DEPARTMENT OF PERMITTING SERVICES

Re: Stormwater Management **CONCEPT** Request
for Silver Spring Gateway
Preliminary Plan #: 1-04039
SM File #: 210383
Tract Size/Zone: 2.86 Ac./CBD-2
Total Concept Area: 3.47
Parcel(s): P925, N926, N871, P815
Watershed: Lower Rock Creek

MEMORANDUM

TO: Wynn Witthans, Development Review Division
FROM: Marilyn Clemens, Community-Based Planning Division
SUBJECT: Silver Spring Gateway Art

Site Plan showing location of seating

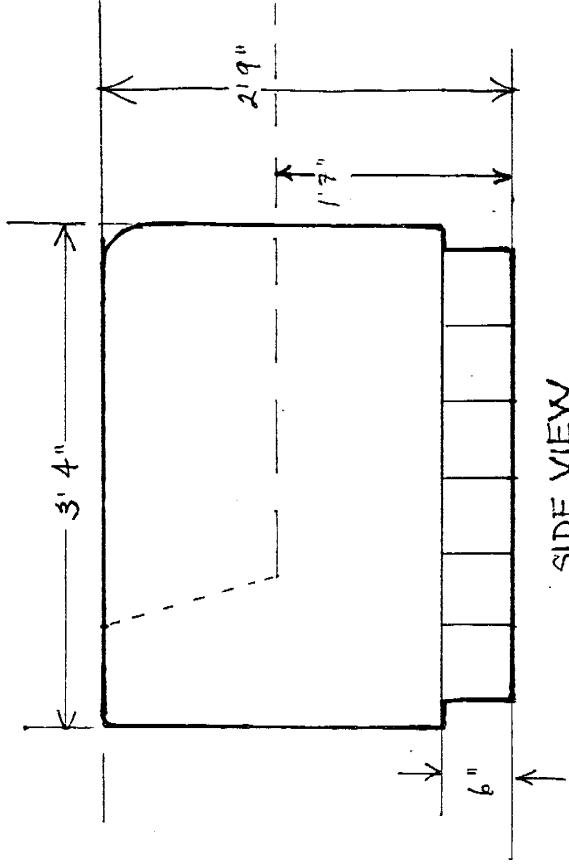
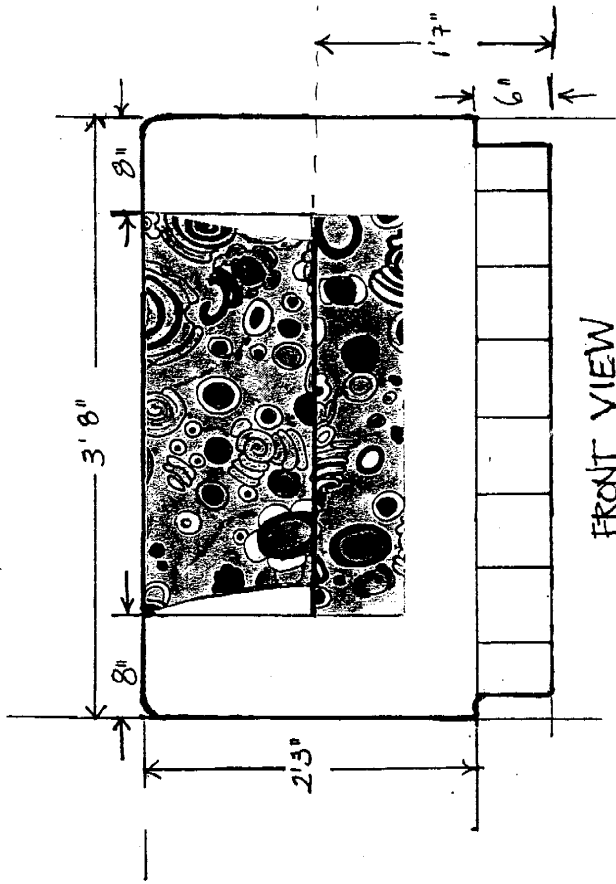
The panelists were enthusiastic about artist Carolyn Braaksma's concrete sculptural furniture and approved the art in concept. They debated two questions: The scale of the furniture and its placement.

If the chairs are life-size, they may be too small to have an impact in a large plaza. Functionally, since they are concrete and not comfortable for long-term seating, as art, they could be larger than life-size for more visual impact.

Another interesting question was the functionality of the spaces, particularly the central space. If immovable chairs are placed in the middle of the central space, it still needs to be a versatile space for pedestrians or small gatherings. On the other hand, the size of central space may be big enough to need a central focal point. In the end, the panelists agreed to leave these decisions to the applicant's consultants, the artist and the staff.
